Exhibition of Eastern Creek Business Hub, Rooty Hill Road South, Eastern Creek - SSD 5175 MOD 5 (Concept Plan) and SSD 8858 (Detailed Design) - Lot 1 Stage 2

Attachment 1 – Office of Environment and Heritage (OEH) comments Exhibition of Eastern Creek Business Hub, Rooty Hill Road South, Eastern Creek - SSD 5175 MOD 5 (Concept Plan) and SSD 8858 (Detailed Design) - Lot 1 Stage 2

Figure 1 – Showing yellow area of existing vegetation impacted by the internal road (extract from Figure 51 – Development Control Plan – Lot 1)

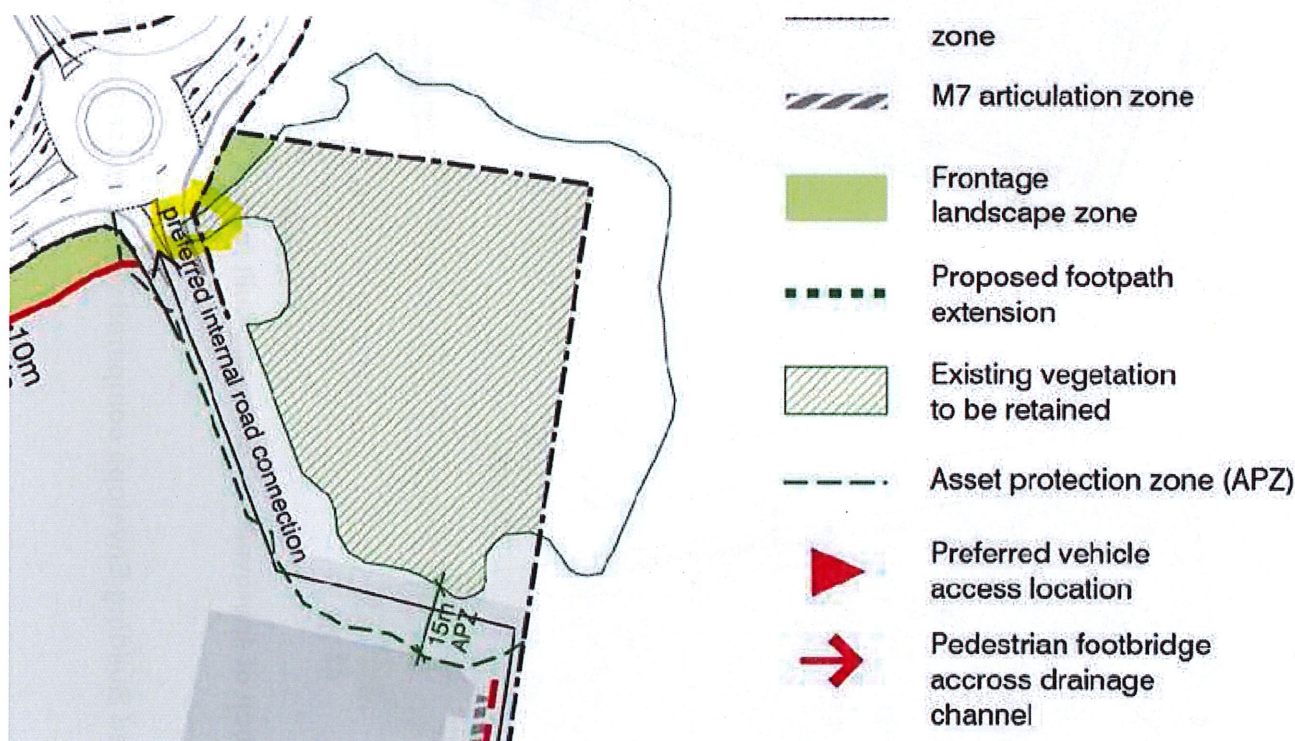
1. The main potential biodiversity impact of this modification is in relation to the new internal access road and roundabout as shown on Figure 51 – Development Control Plan Lot 1. The preferred internal road connection impacts on a small portion of vegetation that is identified as ‘existing vegetation to be retained’ and which forms part of the offset for the site. The impacted area is highlighted in yellow on the extracted map below – Figures 1 and 2 below.

Given this impact, a BDAR will need to be submitted with the SSD 5175 MOD 5. Alternatively, the plans need to be revised to ensure the internal road does not impact this vegetation. OEH cannot grant a BDAR waiver for a modification that has an increased impact on biodiversity values under (s30A(2) Biodiversity Conservation(Savings and Transitional) Regulation 2017).

Figure 2 – Original approved Building Envelope compared with proposed envelope

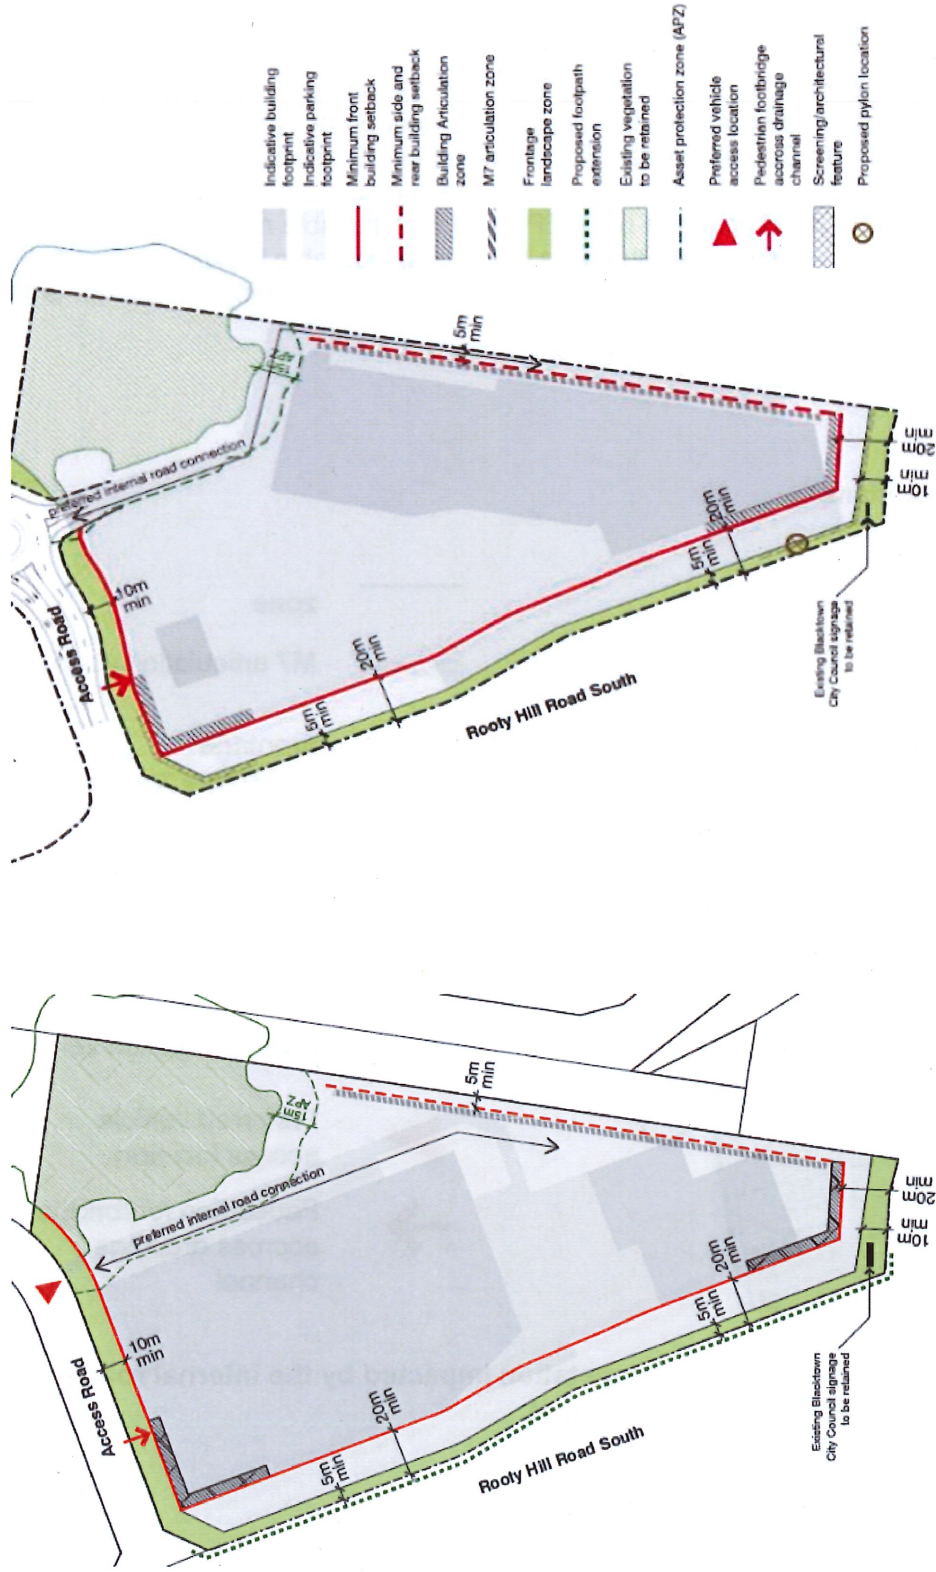
- Aboriginal Cultural Heritage (ACH). There is a significant change and relocation of the building envelopes on Lot 1 from the approved to the proposed design which may impact on ACH (refer to Figure 2).

However, the original concept plan has now been modified several times and this latest proposed modification (SSD 5175 MOD 5) involves significant changes to the location of the building envelopes. It is unclear whether the relocated building envelopes impact on ACH and whether this location on Lot 1 was assessed as part of the original ACHAR. Clarification is required that the original ACHAR included an assessment of all of Lot 1 and the area where the new building
